Special Use Application: SU-SCH 26-0430

LUHO Meeting Date: June 15, 2026

Development Services Department

AGENCY REVIEW COMMENT SHEET

9.0 PROPOSED SITE PLAN (FULL)

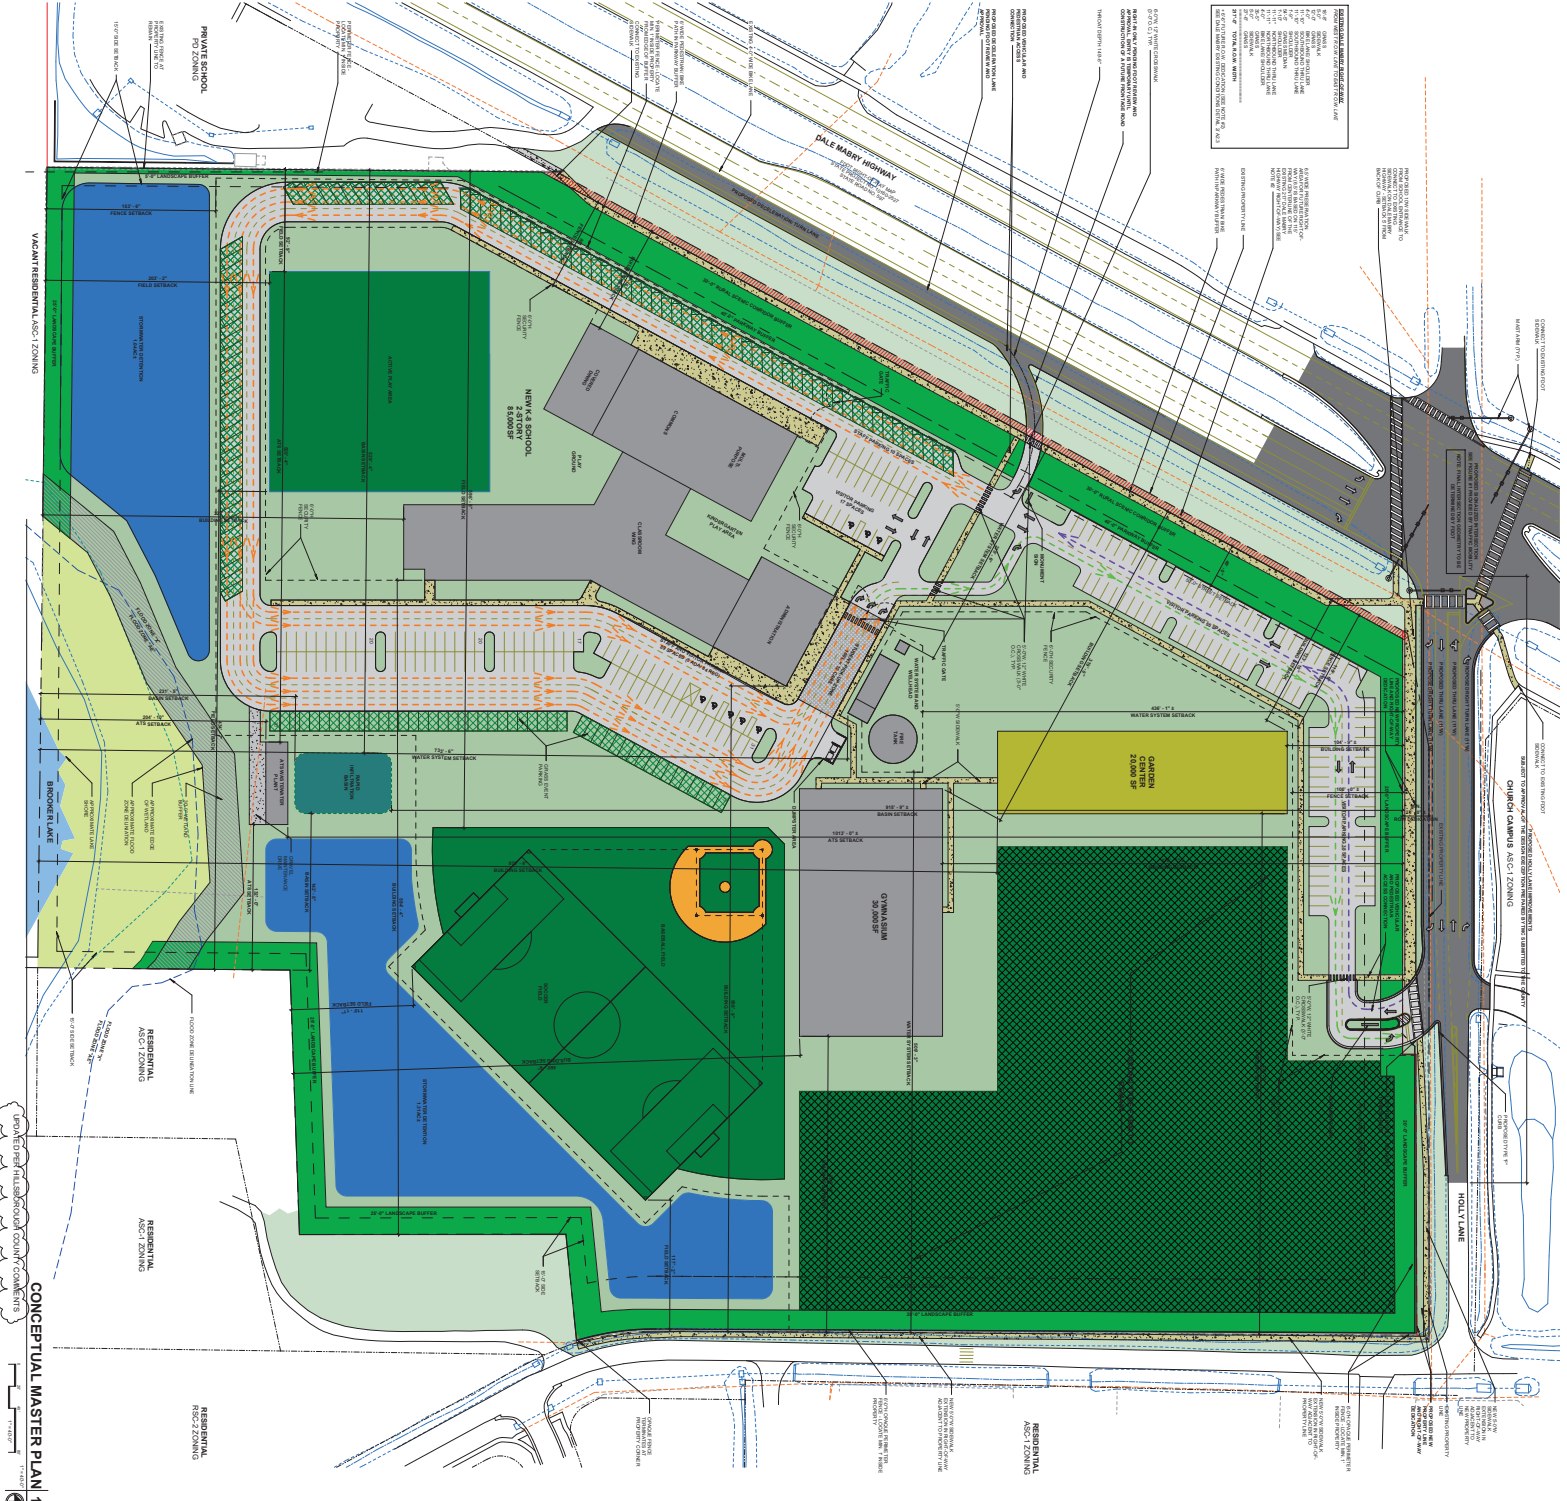
Approval - Approval of the request, subject to the conditions listed below, is based on the general site plan submitted on April 17, 2026.

1. This Special Use Permit shall be limited to a Private School (grades K through 8) with a maximum compacity of 1,000 students.
2. Development shall be as generally depicted on the site plan submitted April 17, 2026, including locations of the athletic fields and accessory structures (Garden Center, Gymnasium, and Wastewater Treatment Plant).

- No fencing shall be placed within the Scenic or Parkway Buffer.
 - A 20-foot-wide landscape buffer shall be provided along the eastern boundary of the property as shown on the site plan.

- A 25-foot-wide landscape buffer shall be provided along the southeastern property boundary adjacent to folio 12523.0000 as shown on the site plan.
4. Development of the site shall be consistent with LDC Section 3.01.06, 3.09.00, 6.11.88, and 6.01.01; unless otherwise specified on the site plan.

12. The project site shall be permitted and limited to one (1) right-in-only access from N Dale Mabry Hwy and one (1) right-in/left-out-only access to Holly Ln.
